## Roads and Maritime Services

Alfords Point Road upgrade, Brushwood Drive to the Georges River
Submissions Report

June 2013

Figure 1 - Proposed Alfords Point Road upgrade

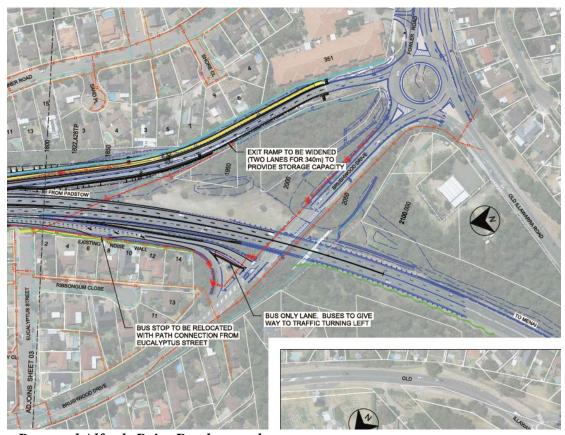
The issues listed are as per the submission from Sutherland Shire Council, further background information has been collected, discussions held with technical experts from RMS from subject matter areas including traffic modelling, traffic management and road safety, and a proposed response has been drafted (for inclusion in the Submissions Report). In addition to the numbered items in council's submission, the overall submission included items listed under specific headings. Where appropriate, these have been grouped with the numbered items.
